North London Waste Authority: New Edmonton ERF

ARUP WRATE Life Cycle Assessment

Independent Peer Review of WRATE Model and Processes

8th June 2015

Figure 1: Schematic of scenario A – all sensitivities

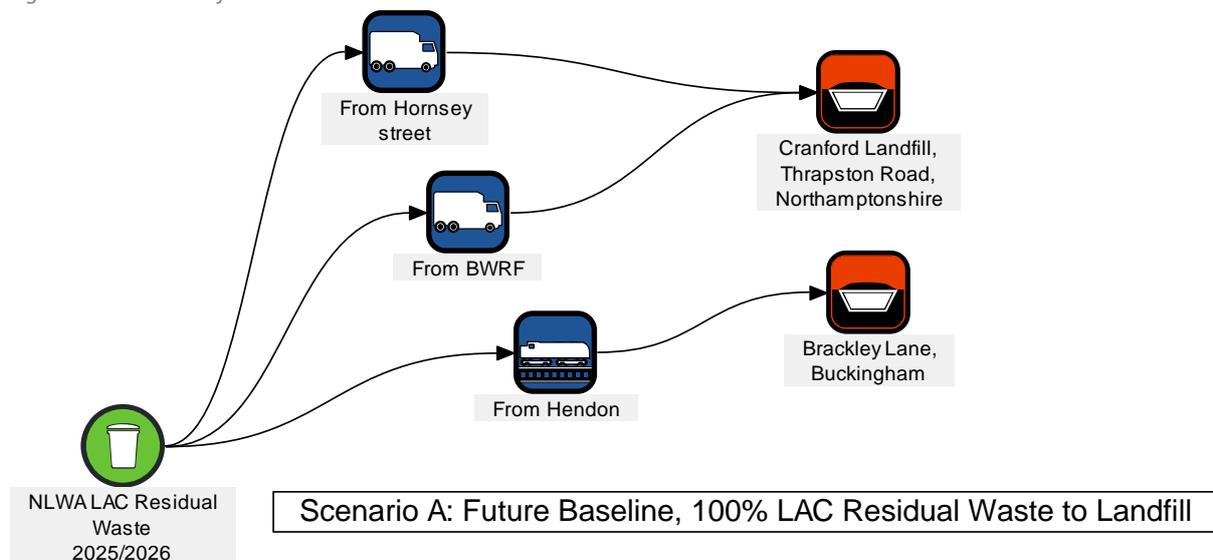
Query 1: Transfer station infrastructure

FRM Query	The inclusion of transfer station processes in the model will allow the model to assess the difference in burdens between use of rail and road transport transfer facilities. The high burdens associated with infrastructure at rail transfer stations will have a greater impact on some scenarios compared with others. Consider including transfer facilities in the scope of assessment.
ARUP Response	The client has confirmed that transfer station infrastructure is out of scope at this stage. Transfer transport processes have not been included.
FRM Comment	This response and approach is acceptable for a high level assessment. If more detailed life cycle assessment is required at a later stage transfer facility burdens should be included within the scope of an assessment.

Figure 2: Schematic of scenario B – all sensitivities

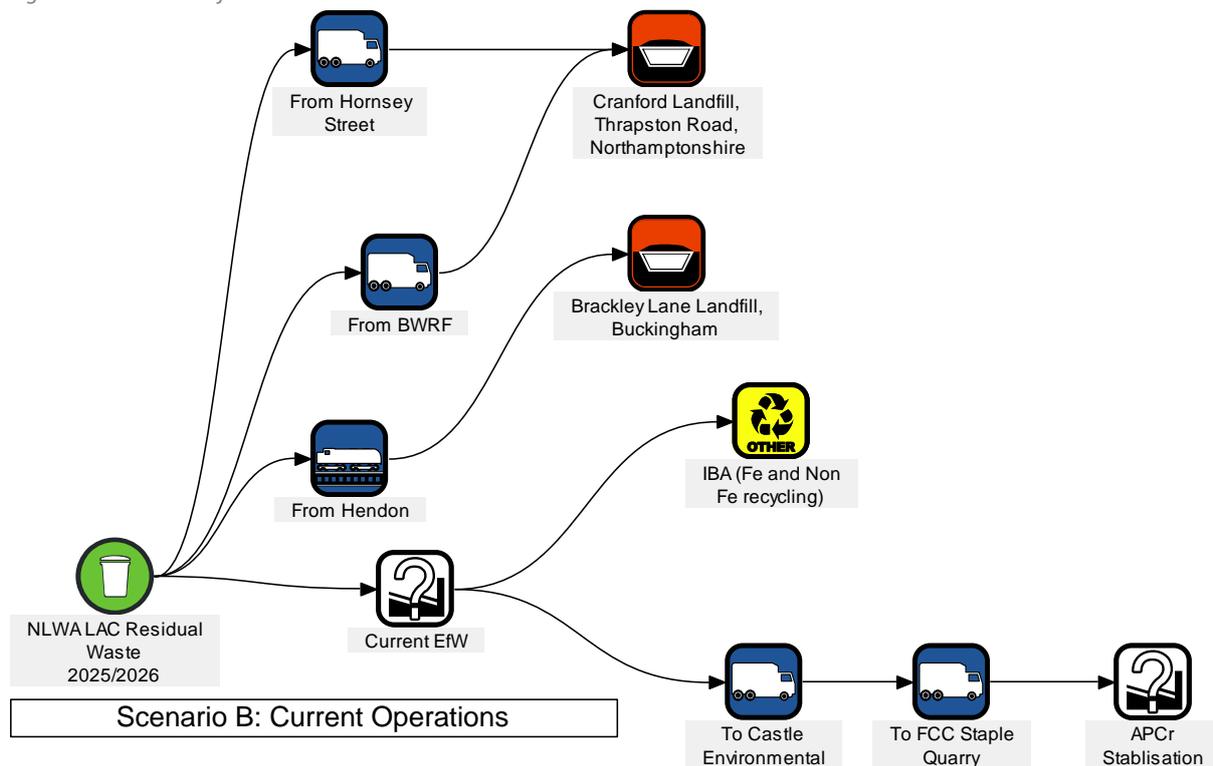
Query 2: Lifespan of current EfW

FRM Query	The extended life of the facility to 55 years will reduce the annualised impact of construction burdens. The current facility will have been refurbished during its current lifespan and would therefore have required major reconstruction works, and therefore it is suggested to revert back to the default 25 year lifespan.
ARUP Response	Agreed. This has been changed back to 25 years to provide a fairer like for like comparison.
FRM Comment	This response is noted and the amended approach is appropriate.

Query 3: Discrepancies between WRATE process net efficiencies and supporting net efficiencies

FRM Query	The electrical efficiency modelled in WRATE for the headline energy output indicator is 20.3427% which differs from the electricity to grid factor of 20.3189%. Consider updating 'electricity to grid' factor to match energy output in order to correctly measure carbon equivalent impacts of offset energy use.
ARUP Response	Amended to match 20.3427%.
FRM Comment	This response and the amended approach are acceptable.

Query 4: Incinerator Bottom Ash (IBA) output

FRM Query	The calculated IBA output (non-metals) is lower than the default WRATE process. We would expect an IBA output (total including metals) of between 20 and 30% of input material. In this scenario a return of 13.999% is achieved. We would suggest that the output of non-metal IBA is increased in line with the default WRATE flexible EfW process.
ARUP Response	Agreed that bottom ash seems low compared to typical values for similar facilities. However 13.999% of input material reflects the mass balance data for 2013/14 as provided by NLWA for the current EfW facility.
FRM Comment	This response is acceptable as the IBA from the current EfW is measured rather than estimated in the 2013/14 data. Therefore FRM agree that, although lower than standard EfW performance, this is an acceptable approach to modelling in WRATE having been provided with evidenced mass balance data.

Query 5: APCr output

FRM Query	The calculated APC residues output is lower than the default WRATE process. We would expect an APCr output of between 3.5 and 4.5% of input material depending on the abatement control method selected. In this scenario a return of 3.368% is achieved. We would suggest that the output APCr is increased in line with the default WRATE flexible EfW process.
ARUP Response	Mass of APCr (info as provided by NLWA) for 2013/14 from current EfW is

17,985 tonnes. Factored to current operations in 2025 (factor of 1.011 compared to 2013/14) this gives 18,187 tonnes of APCr or 3.368% of input material.
FRM Comment	This response is acceptable as the APCr from the current EfW is measured rather than estimated in the 2013/14 data. Therefore FRM agree that, although lower than standard EfW performance, this is an acceptable approach to modelling in WRATE having been provided with evidenced mass balance data. Further, although the figure falls outside values modelled by the WRATE default processes, it is still within industry ranges and therefore an acceptable use of the WRATE model.

Figure 3: Schematic of Scenario C – all sensitivities

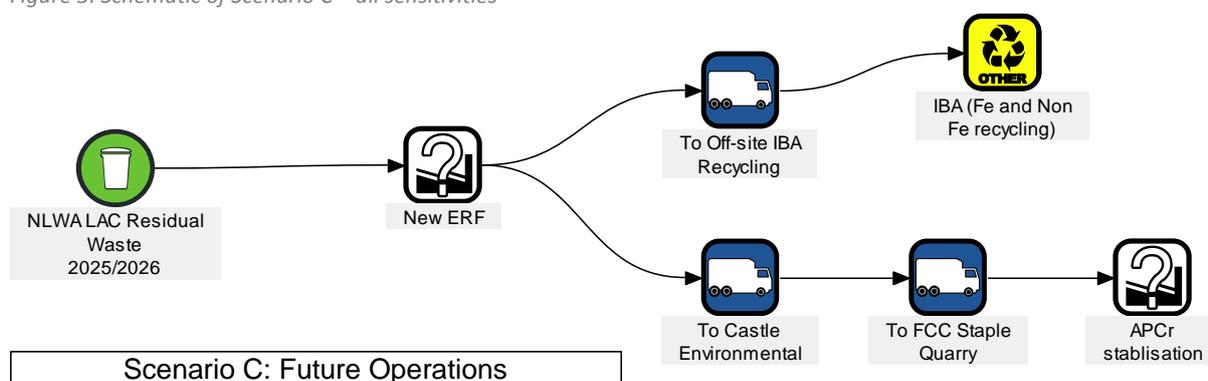
Query 6: ERF process energy efficiency discrepancy

FRM Query	<p>There is a discrepancy between the user defined WRATE process efficiencies and those presented in the energy balance. For the main model, and Sensitivities 2 and 3, the WRATE process is modelled with efficiencies of 30.083% (electrical) and 20% (thermal), whilst the calculated energy balance figures are 30.1184% and 20.0223% respectively. This results in the WRATE model being more conservative with a 0.12% reduction in energy generation compared to the calculated output in the energy balance. There will be associated, albeit small, impacts on avoided emissions as a result of this also negatively affecting the solutions modelled performance.</p> <p>For Sensitivity 1 the thermal efficiency input in WRATE is 19.99%, whereas the energy balance suggests an efficiency of 20.02%, again resulting in a conservative energy output. Sensitivity 4 is modelled in line with the energy balance with regards energy efficiencies of the technology.</p> <p>It is recommended that the efficiencies are updated to match the energy balance provided.</p>

ARUP Response	<p>This is in part due to net CV within WRATE changing. Based on the NLWA waste composition WRATE originally calculated the net CV as 8.55 MJ/kg. For reasons unknown WRATE now calculates the net CV MJ/kg as 8.54, and seems to have stabilised as this value after repeat re-calculations of the model. It may be a rounding error within the software. This discrepancy makes a slight difference to the factor applied to the efficiencies to mimic a CV of 10 MJ/kg.</p> <p>All values amended and checked so now correct and consistent.</p>
FRM Comment	<p>This response is noted and the amended approach is appropriate.</p>

Figure 4: Schematic of Scenario D – all sensitivities

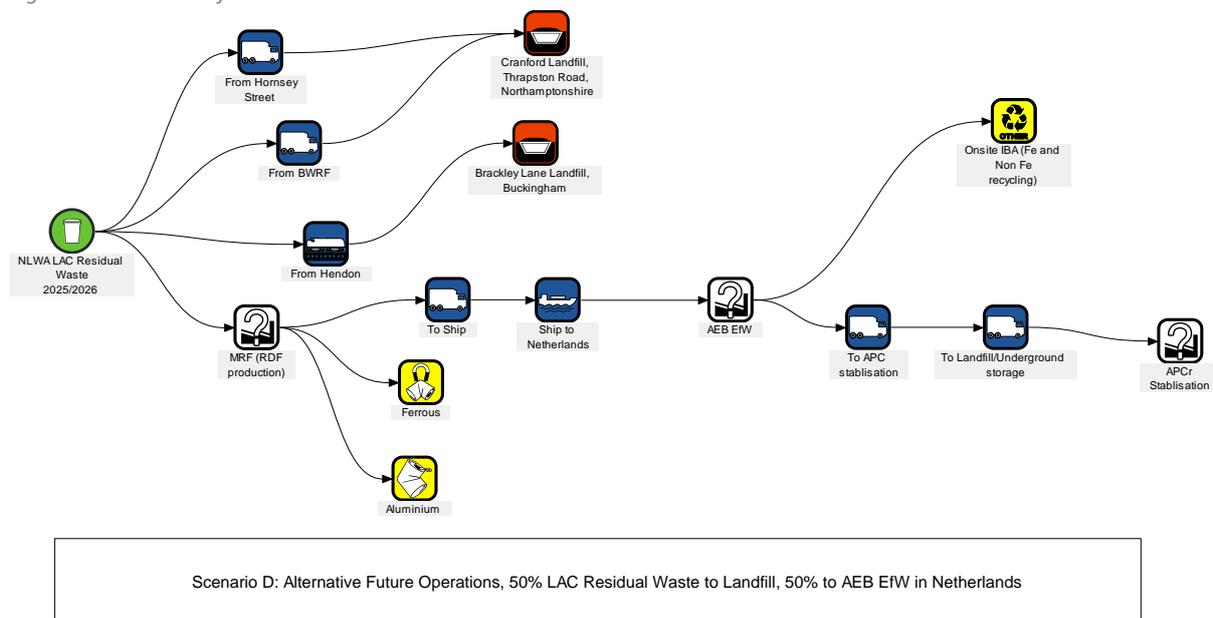
Query 7: Miscellaneous waste distribution

FRM Query	In previous scenarios waste has been distributed 10.54:21.41:68.05 to Hornsey Street (road transfer station), BWRF (road transfer station) and Hendon (rail transfer station) respectively. In Scenario D Hendon street is modelled correctly, however waste destined for BWRF appears to have been erroneously modelled through Hendon and vice versa. This error requires remodelling of the scenario and all associated sensitivities.
ARUP Response	This has been corrected.
FRM Comment	This response is noted and the amended approach is appropriate.

This scenario has been amended from a previous version, to include a dirty MRF to extract metals and form a crude RDF for export to the AEB Energy from Waste plant in Amsterdam. The energy balance has been changed to reflect the AEB plant, handling 50% of the contract waste. The remodelled ERF process has WRATE ID 11381, and is detailed in
